Variance Petition No. 201303671

Board of Appeals Hearing
January 9, 2014

Prepared by the City of Sandy Springs Department of Community Development for the Board of Appeals Hearing on January 9, 2014.

Parcel Map

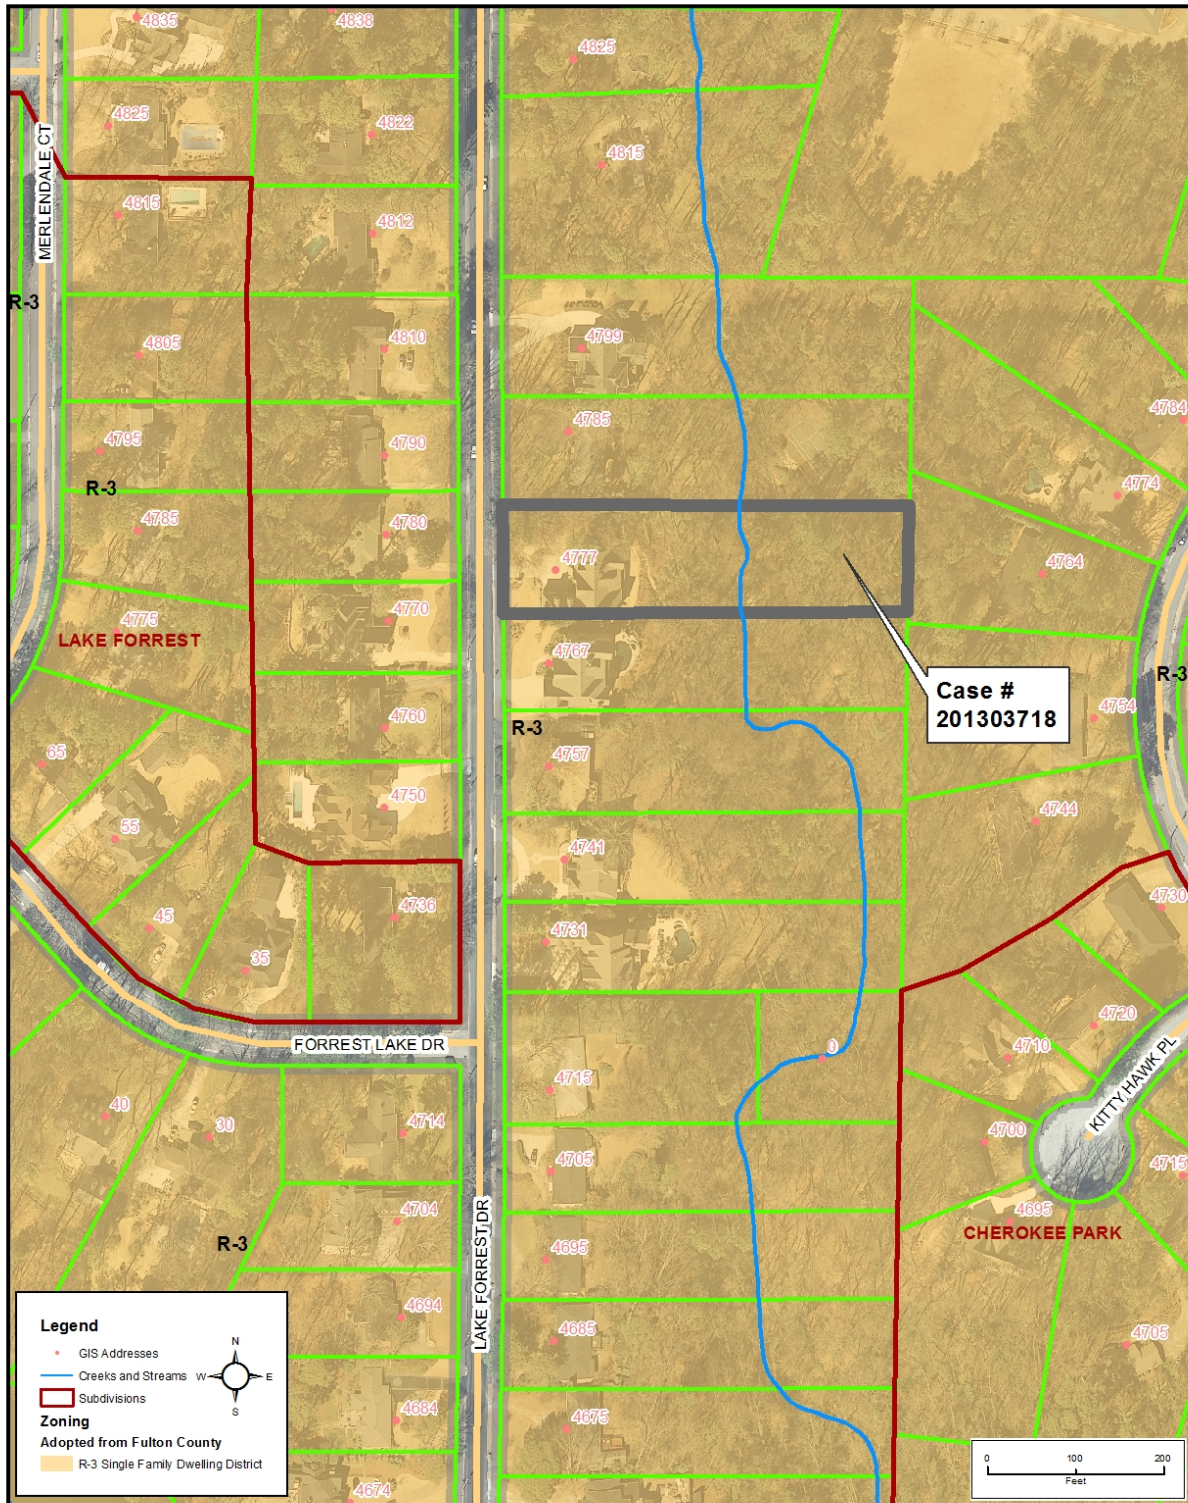
The property's shape, topography, and physical conditions existed at the time of the adoption of the ordinance. Staff notes that the property is regular in shape, and exceeds the minimum lot area for the zoning district. There are significant changes in topography; however, they have not limited development of the parcel. Based on these reasons, staff is of the opinion this condition has not been satisfied.

The property does not exhibit an unusual circumstance when the minimum buffer requirement is strictly applied. The current lot is developed with a single family residence, an additional buildable area is available. Based on these reasons, staff is of the opinion this condition has not been satisfied.

As previously mentioned, the property is regular in shape with topographical challenges; however the topographical challenges have not limited the buildable area of the lot. Staff is of the opinion that the property does not exhibit extraordinary and exceptional conditions related to its size, shape, or topography.

Transportation:	• Lake Forrest Drive is on the Sidewalk Master Plan network. • Public works supports revegetation of the stream buffer above the minimum standards.
Arborist:	• Due to the amount of impervious surface and the location of the proposed sidewalk traveling parallel to the setback an alternative location should be considered.

Staff has reviewed the request relative to the variance standards contained in Section 109.225 of the Sandy Springs Stream Buffer Protection Ordinance. Based upon this review, staff recommends **DENIAL** of this variance request to allow for construction of a sidewalk.

- 1) To reduce the required seventy-five (75) foot impervious surface setback and fifty (50) foot undisturbed buffer to allow construction of a path, as shown on the site plan dated received November 7, 2013 by the Department of Community Development.

Parcel Map

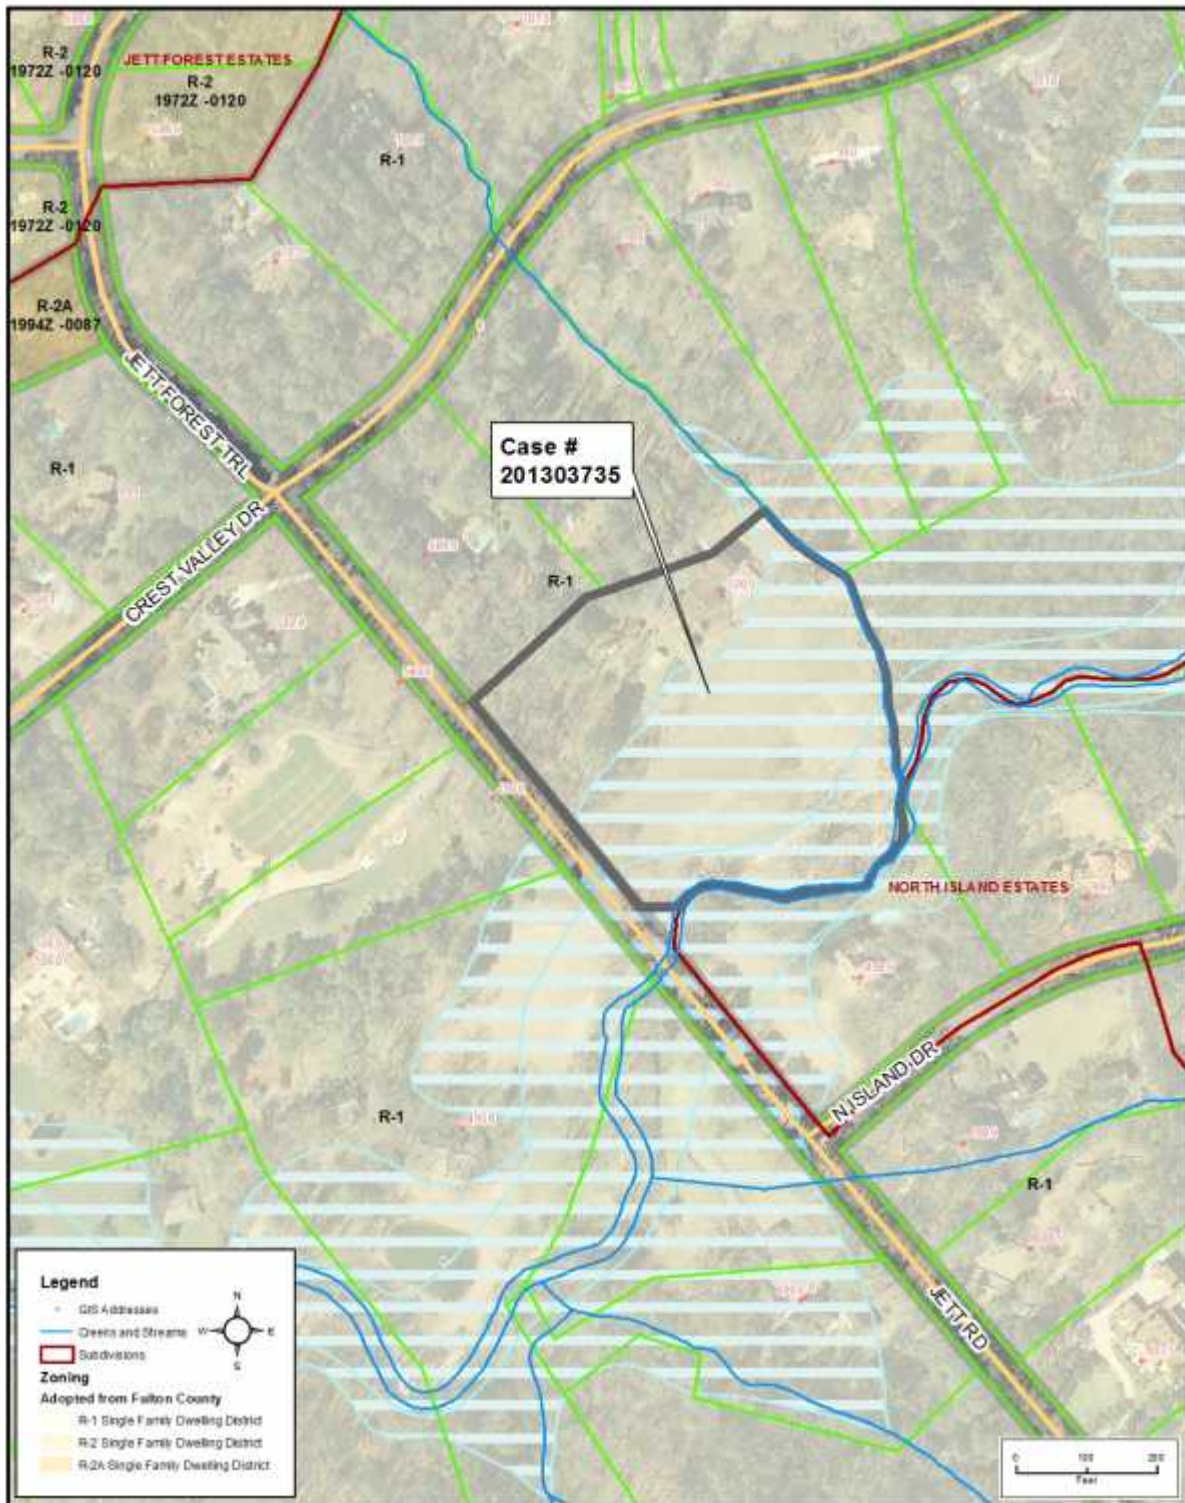
The property's shape, topography, and physical conditions existed at the time of the adoption of the ordinance. Staff notes that the property is irregular in shape with minimal topographical grade changes. The applicant's entire rear yard is covered by the stream buffer, which accounts for approximately two-fifths (2/5) of the land area along the property's northern and eastern edges. However, the applicant's side yard, adjacent to Long Island Creek and front yard, along Jett Road, account for nearly three acres of land not in the stream buffer. Based on these reasons, staff is of the opinion this condition has not been satisfied.

The property does not exhibit an unusual circumstance when the minimum buffer requirement is strictly applied. The applicant has approximately three (3) acres of land outside of the stream buffer. If the applicant were to adhere to minimal requirements, the garden could go in either the side or front yard without disrupting the stream buffer. Based on these reasons, staff is of the opinion this condition has not been satisfied.

As previously mentioned, the property is irregular in shape and the topography is relatively flat. The stream buffer runs along the northern and easterly property boundaries and account for approximately two-fifths (2/5) of the land area. Therefore, nearly three (3) acres of land sits outside of the stream buffer. Staff is of the opinion that the property does not exhibit extraordinary and exceptional conditions related to its size, shape, or topography.

Transportation	))	Jett Road is on the Sidewalk Master Plan network Public works supports revegetation of the stream buffer with native plant materials.
Arborist	))	Encroachment into the 25' state buffer cannot exceed 100 sq.ft. If the Board decides to approve the variance in the City stream buffer the requirement of planting the garden with native riparian vegetation should be included in the conditions.

Staff has reviewed the request relative to the variance standards contained in Section 109.225 of the Sandy Springs Stream Buffer Protection Ordinance. Based upon this review, staff recommends **DENIAL** of this variance request to allow for the construction of a rain garden.

- 1) To reduce the required seventy-five (75) foot impervious surface setback and the fifty (50) foot undisturbed natural buffer to allow for the construction of a rain garden, as shown on the site plan dated received November 8, 2013 by the Department of Community Development.
